***MODIFICATION REQUEST:  
Mixed Use Development, 330 Church  
Street, Parramatta  
MP 10\_0171 MOD 3***

Director-General's  
Environmental Assessment Report  
Section 75W of the  
*Environmental Planning and Assessment Act 1979*

November 2013

**Figure 9:** Comparison of Proposed Modification and the Height Limit for the Site Recommended by GMU

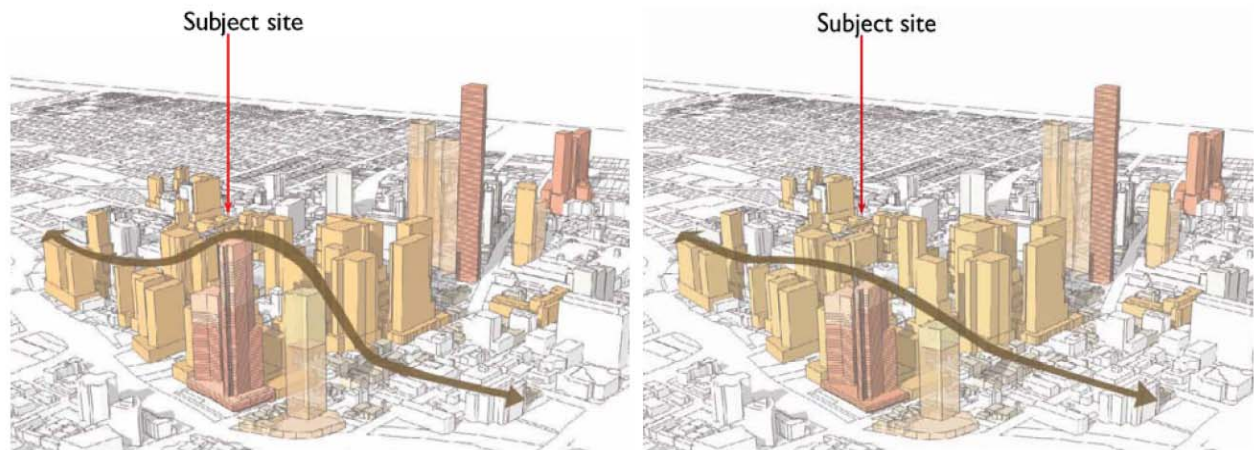
- Currently there is no discernible city skyline or height marker within the centre of the CBD;
- Additional height on the subject site would assist in marking the northern gateway to the city centre. However, the proposed height at this location would still be in direct contrast with the maximum heights permitted along the southern bank of the Parramatta River. In this regard, the height of the western tower does not provide an appropriate transition between the centre and the periphery of the CBD, or between the lower scale development proposed immediately east and west of the site along the riverfront;

- Increasing the height of the western tower would alter the relationship between both towers to one that is less balanced and harmonious. However, the additional height proposed on the eastern tower would result in an improved design outcome, as the tower would appear more elegant and slender;

- There are no adverse impacts associated with increasing the height of the podium; and
- In order to provide a smoother transition between the centre and the periphery of the CBD, and the adjoining development east and west of the site, GMU recommends that the western tower should be reduced in height by between six and eight storeys as per **Figures 9 and 10** overleaf.

**Figure 11:** Subject Site as Viewed from OGH and The Domain

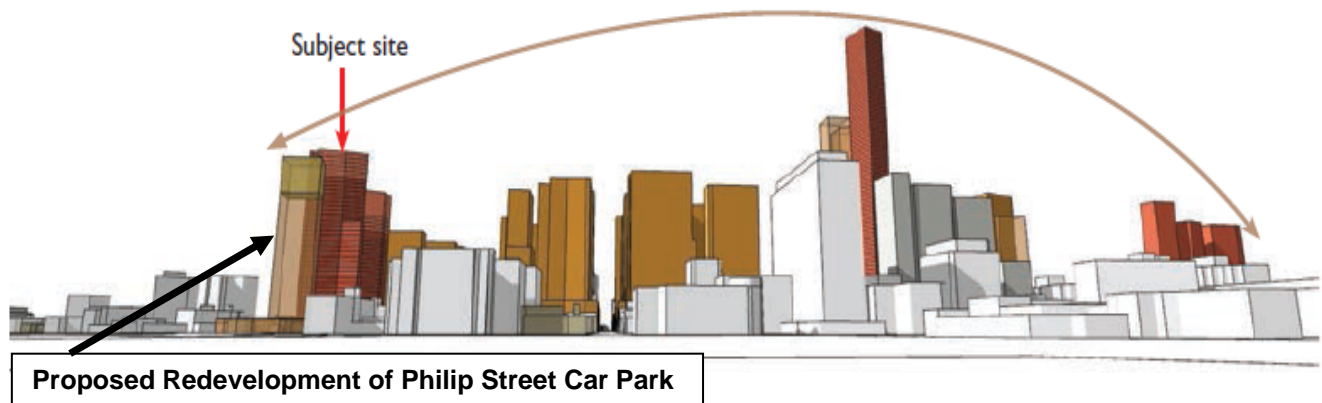
- The proposed modifications to the towers would be highly visible from many parts of Parramatta. However, locations close to the site within the CBD would be less affected due to intervening built components in comparison to sites located further afield such as OGH and The Domain, Prince Alfred Park, The Old Kings School or Dixon Park;

- In the context of a proposed tall building immediately west of the site (Philip Street Car Park), the proposed increase in the height of the approved towers is unlikely to cause any significant cumulative visual impact (see **Figure 11** below);

**Figure 13: Overshadowing Impacts of the Proposed Modification at Winter Solstice**

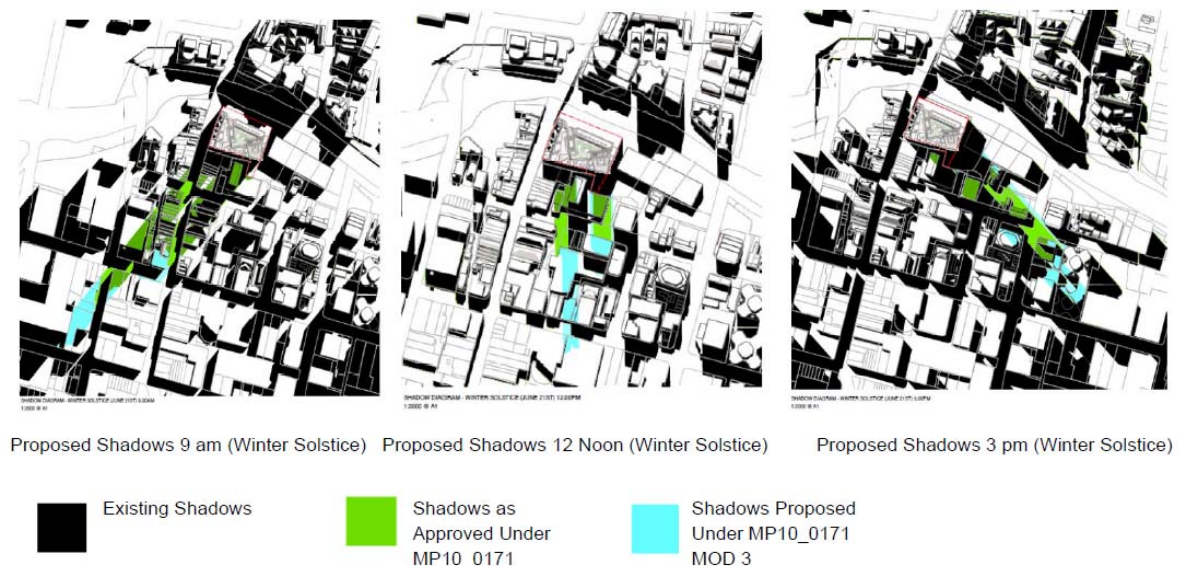
The department has compared the shadow impacts of the approved project and the proposed modification and has concluded that the application would result in the following additional impacts during the winter solstice:

These impacts are depicted in **Figures 12 and 13**. Based on the above the department considers that the extent of the additional overshadowing is minor and acceptable.

**Figure 14:** Revised Ground Floor Configuration

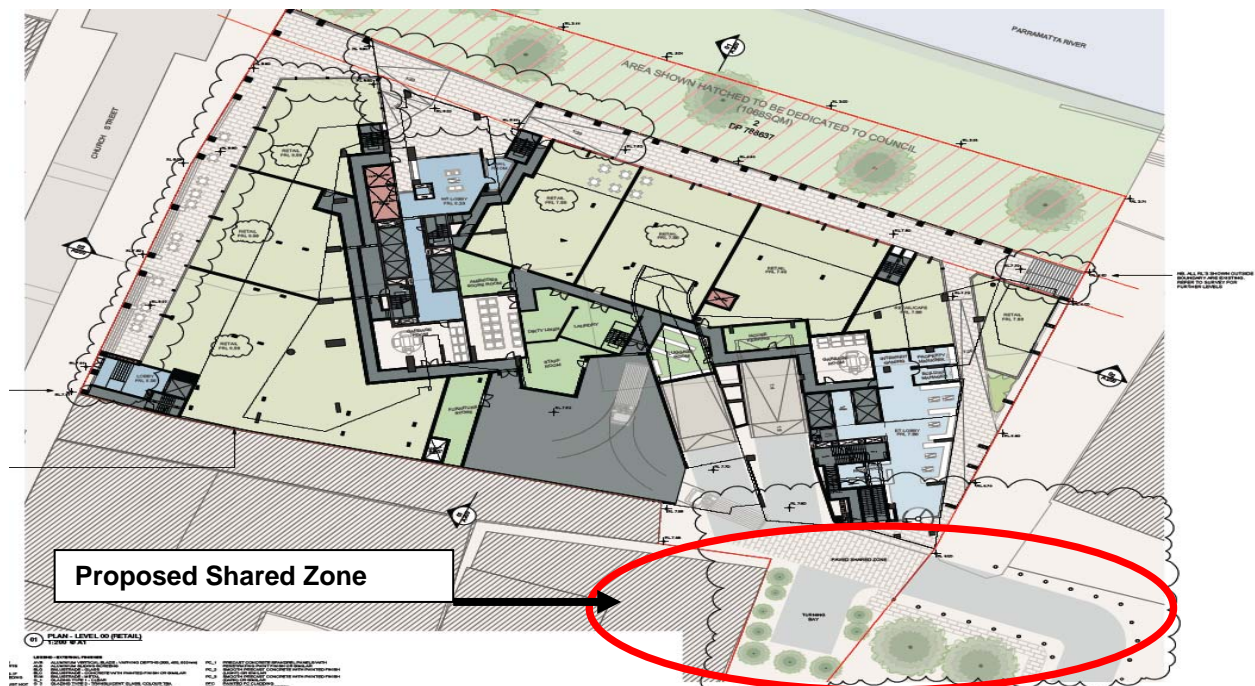
The application seeks approval to revise the entry and exit configuration of the car park and provide car parking within the podium level. The department has reviewed the proposed modifications to the car park design, as amended by the supplementary report provided by the proponent on 4 November 2013, and notes that the issues previously raised by the council in relation to non-compliances with the relevant Australian Standards have now been addressed.

In addition, the department notes that the supplementary documentation dated 4 November 2013, proposes to create a landscaped shared zone at the rear of the site (see **Figure 14** overleaf). The department has reviewed the design of the shared zone and is satisfied that it has been designed to integrate with the future laneway proposed on the southern boundary of the site. In addition, the department considers that it provides a satisfactory response to the issues by the owner of the adjoining site (328 Church Street) in relation to vehicle access.

Accordingly, the department is satisfied the design of the basement car park is appropriate.

**Figure 15:** Extent of Existing Flood Prone Land

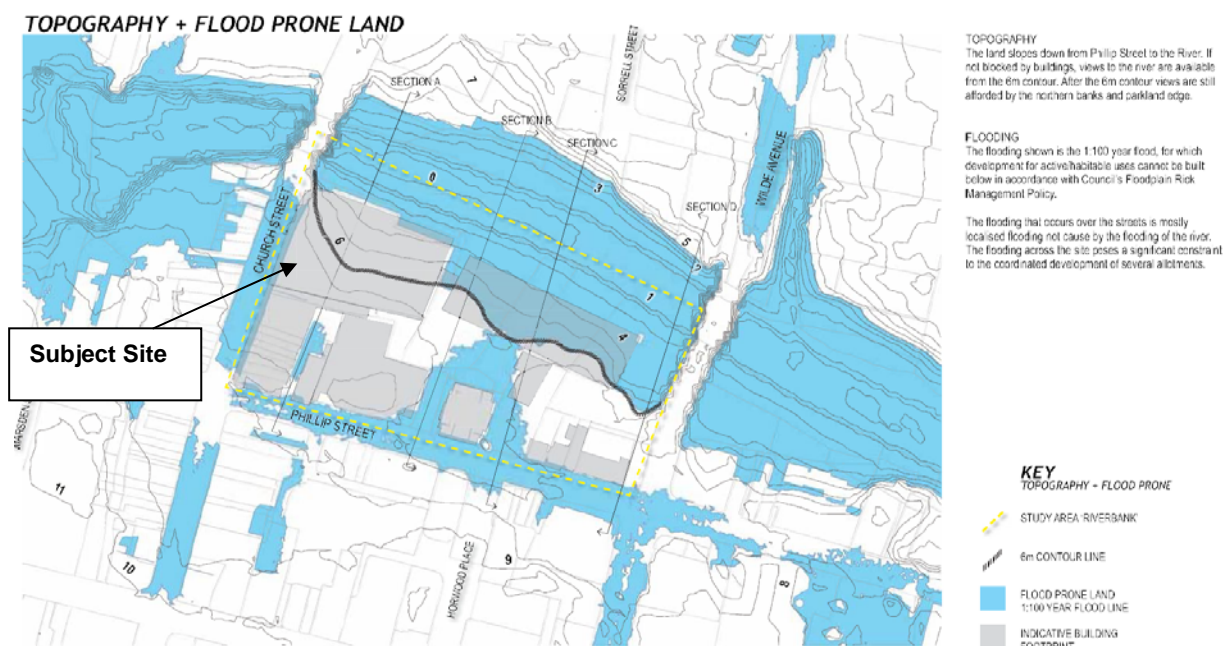
As the site is surrounded by flood prone land (see **Figure 15**), the department imposed conditions on the original project approval (Conditions B12 to B14, E9 and 10, and F8) to ensure all finished floor levels would achieve a 500 mm freeboard from the 1 in 100 year flood level, and appropriate flood risk management measures would be designed, implemented and maintained on-site. In this regard, the following flood planning levels apply across the site:

- RL 6.59 m along the northern boundary of the site;
- RL 7.48 m on the eastern and southern boundaries of the site;
- RL 8.8 m on the western boundary of the site; and
- RL 7.48 m on the eastern and southern boundary of the site

The department has reviewed the ground floor plans submitted by the proponent on 4 November 2013, and has concluded that the application would not alter the approved building envelope and complies with the flood planning levels specified in the current Instrument of Approval. Notwithstanding, the department notes that Condition B12 will need to be modified to:
